TO: Design Review Board
FROM: Christi Schmidt, Senior Planner
DATE: February 4, 2020
SUBJECT: February 20, DESIGN REVIEW BOARD MEETING – THE FARM GARAGES

DESIGN REVIEW #3 - BUILDINGS E1, E2, E3 AND E4

**CITY OF MILL CREEK
DESIGN REVIEW BOARD
APPLICATION PL2020-0002**

NAME OF PROJECT: Crestview Village Phase II
Roadway Buffer Landscaping and Streetscape

04 SOUTH ELEVATION - ADA GARAGE (E2)
SCALE: 1/8" = 1'-0"

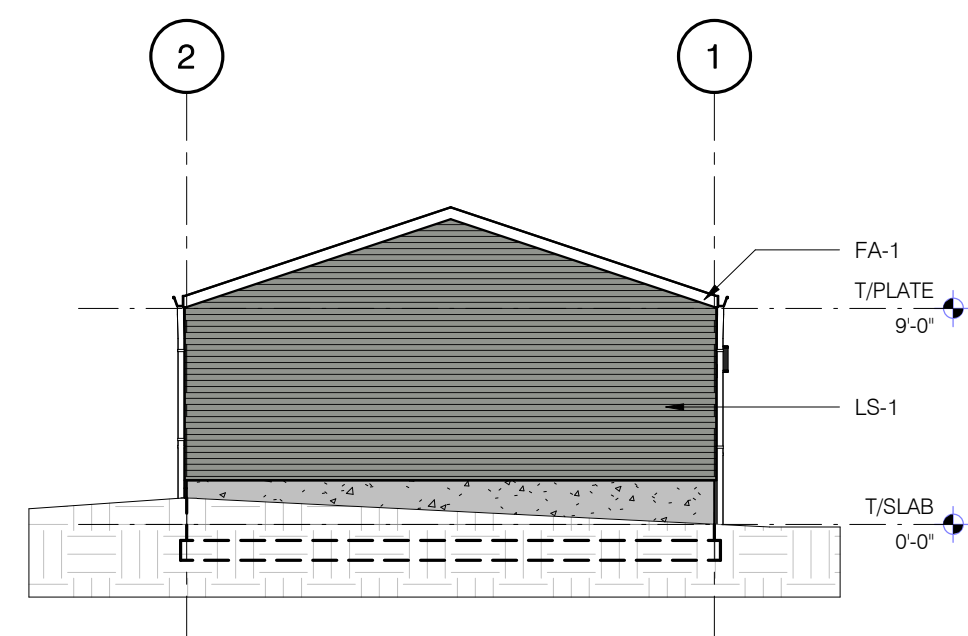
The southern building elevations for E1-E4 shall be revised to include a vertical element that meets the façade modulation/break-up of every 36 feet of lineal building length. The vertical element shall be in a complimentary color with adjacent buildings. The revised elevations shall be submitted back to the Design Review Board for review and approval.

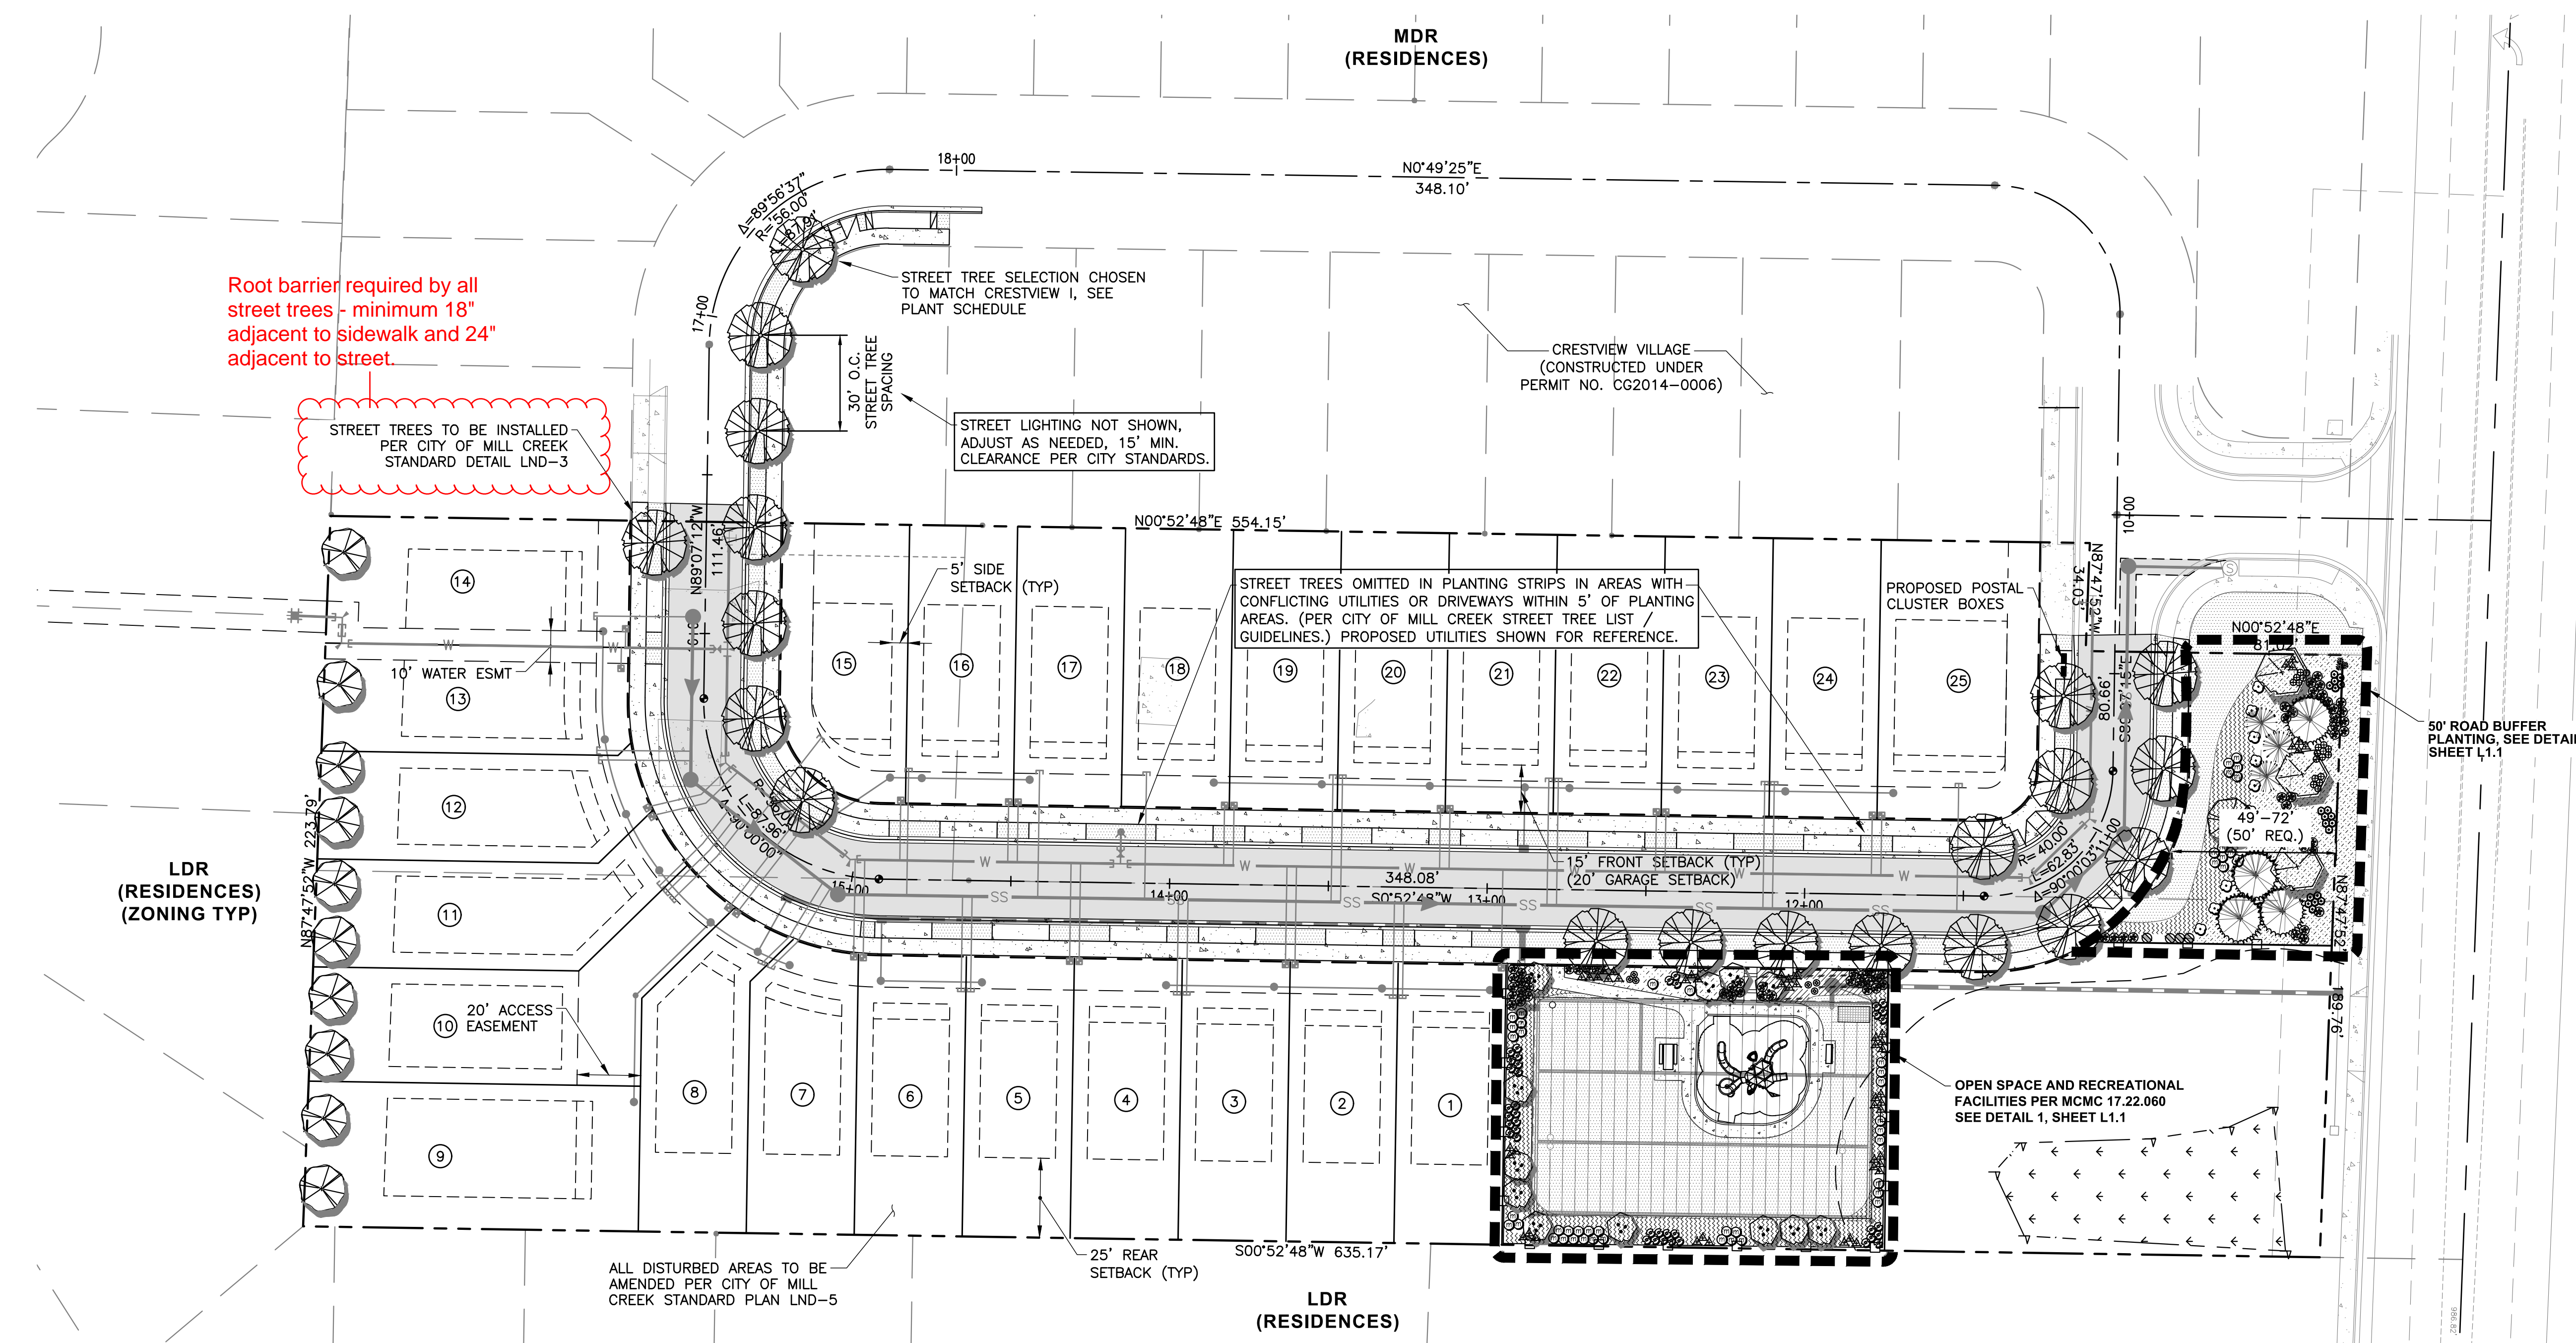
2. Revise the landscape plan as follows:
 - Add a note regarding the requirement for root barrier when the tree is within five feet of a paved surface; i.e., all street trees.

- Add a note regarding amending the soil in the planter strip to ensure a good planting bed for the street trees.
3. A landscape performance bond in the amount of 125% of the proposed cost of materials and installation shall be provided to the City prior to installation of the landscaping, pursuant to MCMC Section 16.16.040.
